REVISED RESPONSE TO REQUEST FOR ADDITIONAL INFORMATION

APR1400 Design Certification

Docket No. 52-046

RAI No.: 205-8230
SRP Section: 11.03 - Gaseous Waste Management System
Application Section: 11.3
Date of RAI Issue: 09/08/2015

Figure 11.3-1 Gaseous Radwaste System Flow Diagram

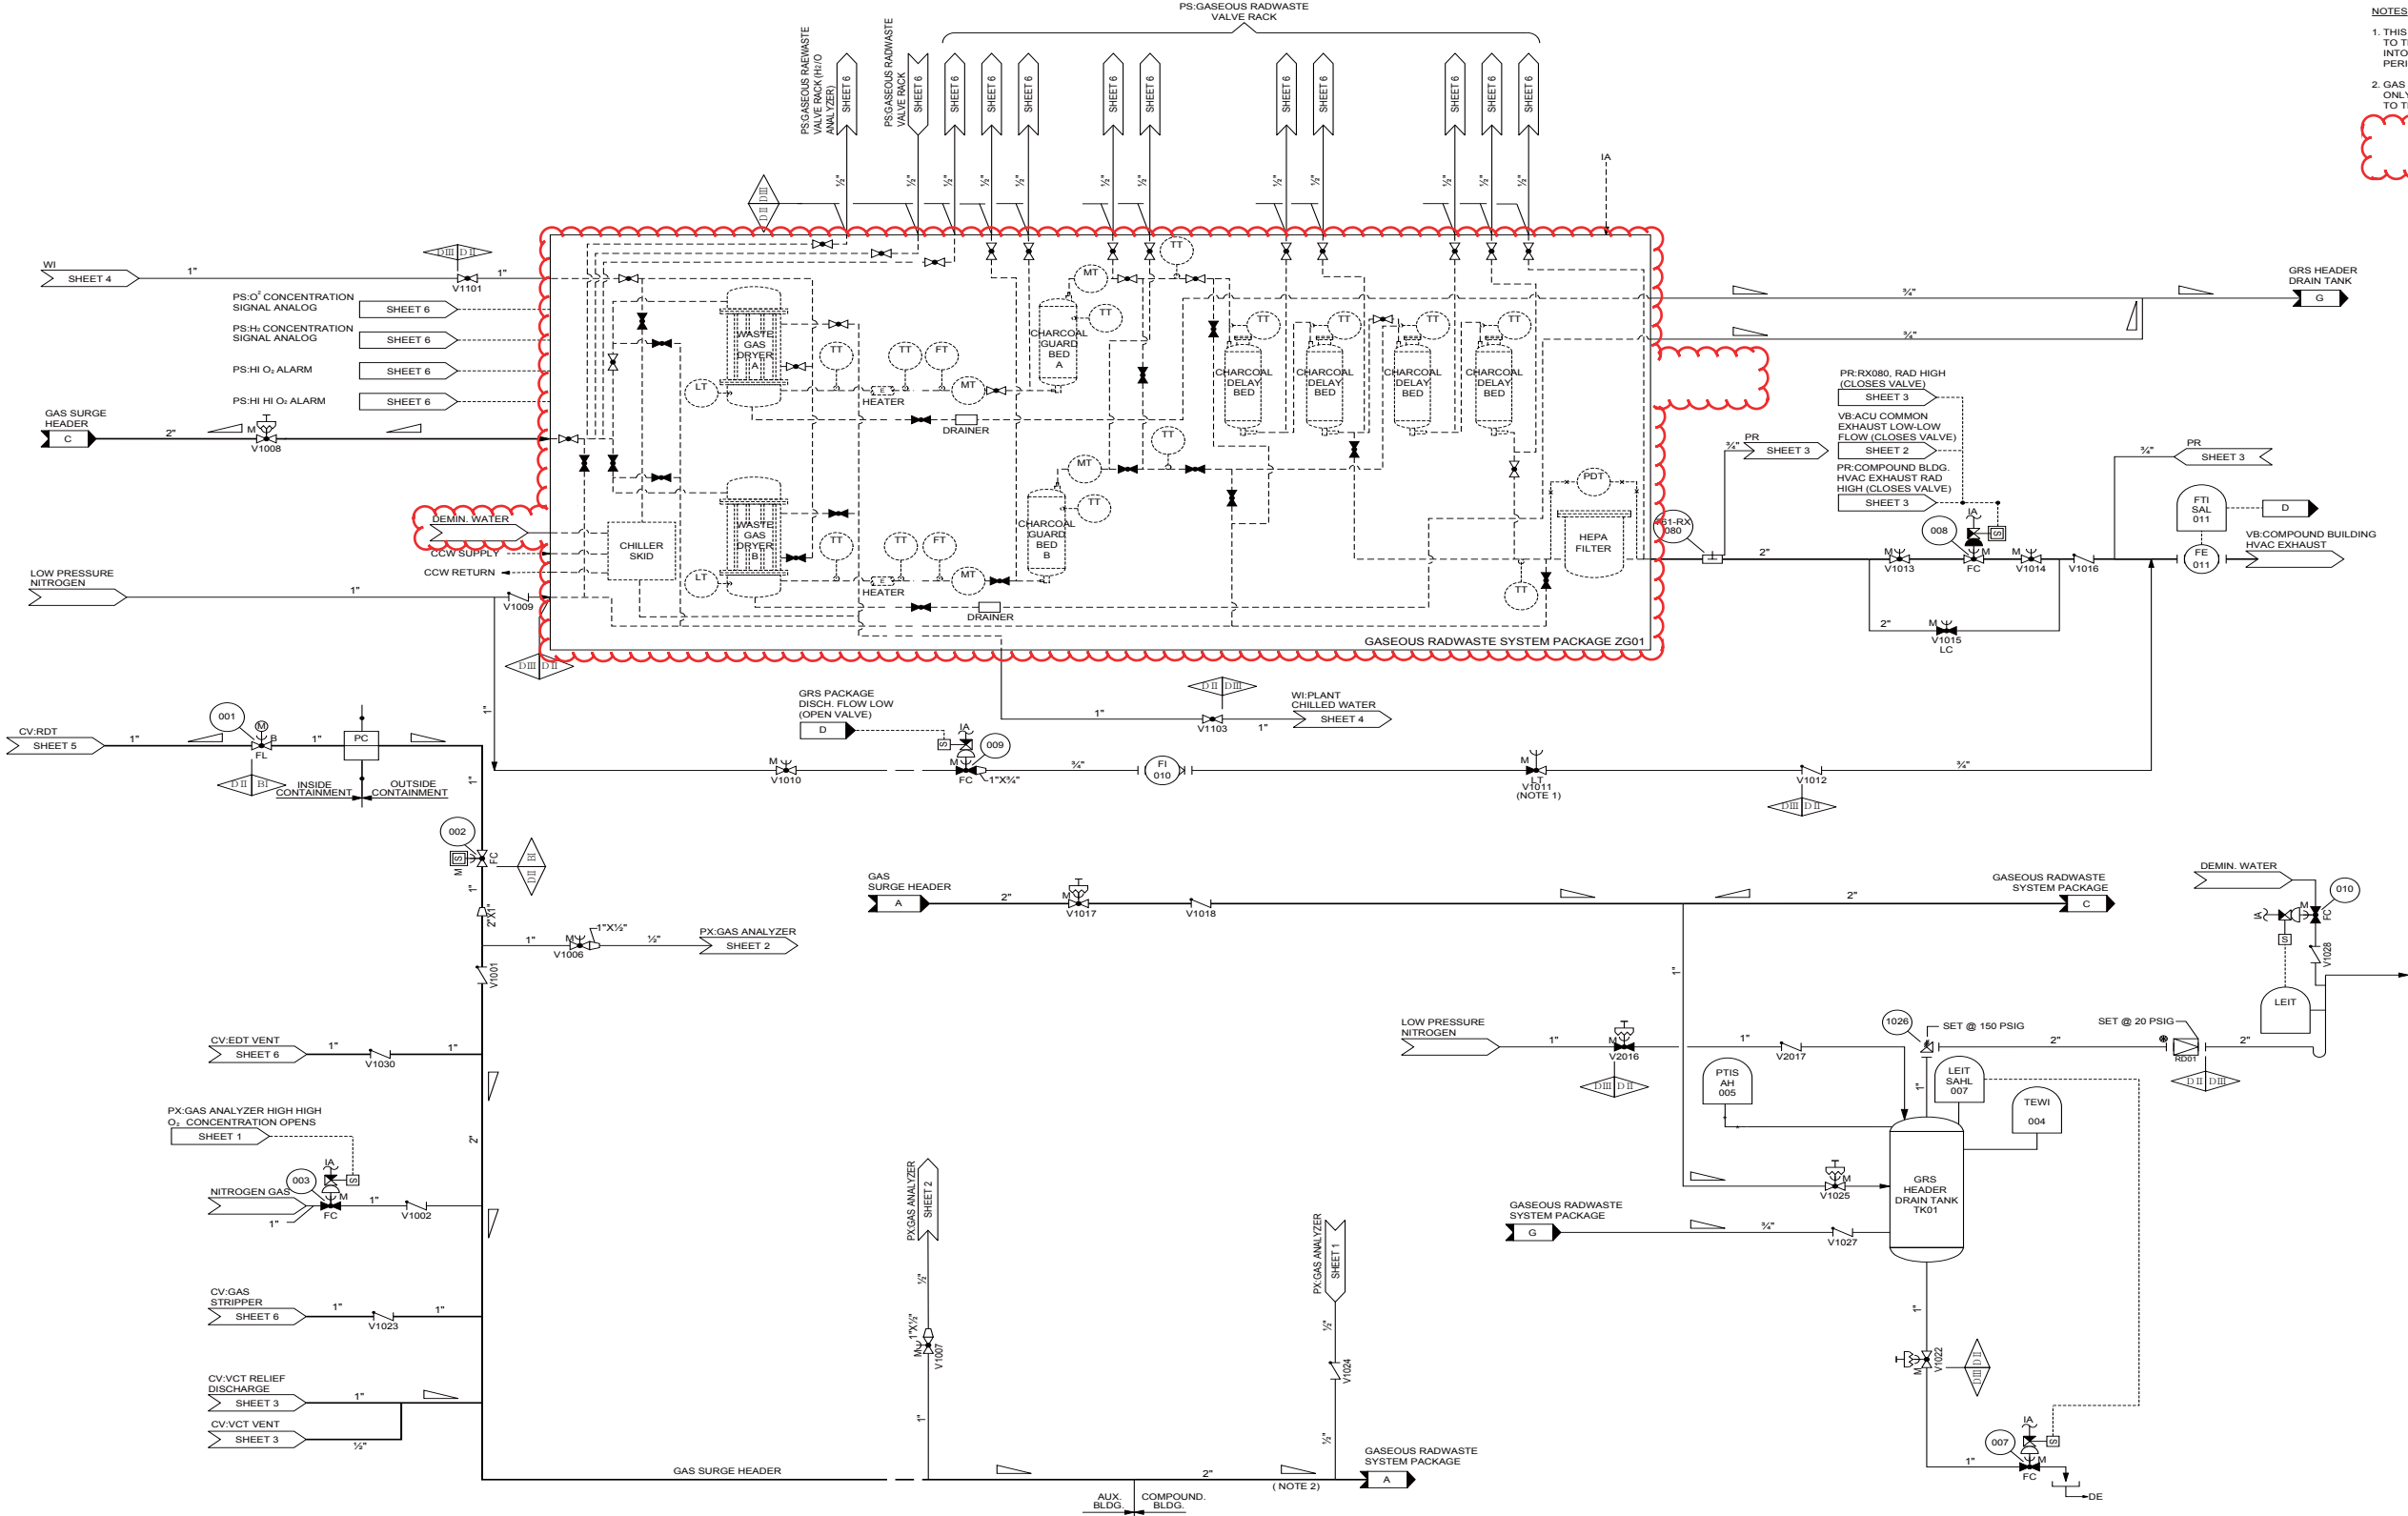
1. Provide a description of the processes in place to monitor conditions for a fire in the charcoal delay beds.
2. Describe how potential leaks of the chilled water system are monitored and what measures would be taken to address water inside the charcoal delay beds. This should also include a description for how the applicant anticipates the corrosion inhibiting chemicals added from the chilled water would affect the charcoal delay beds.
3. Provide a description for the use of differential pressure sensors on the charcoal delay bed. What measures are in place for the applicant to detect any potential clogs in the charcoal delay beds?
4. Information is requested defining the flow paths and the chilled water flow path that acts to control temperature.

3. The basic flow diagram for GRS package [will be](#) provided in [DCD Tier 2, Figure 11.3-1](#). The flow diagram includes the process and chilled water flow path. Potential clogs or blockages are not expected in the charcoal delay bed because the process gas is transferred from the CVCS equipment processing reactor grade water, as described in Section 9.3.4, and may not contain particulates leading to potential clogs in charcoal delay beds.

4. The basic flow diagram for GRS package [will be](#) provided in [DCD Tier 2, Figure 11.3-1](#).

[DCD Tier 2, Section 11.3.2, 11.3.2.1.1, 11.3.2.1.2, 11.3.2.1.4 and Figure 11.3-1 will be revised as indicated in the attached markup.](#)
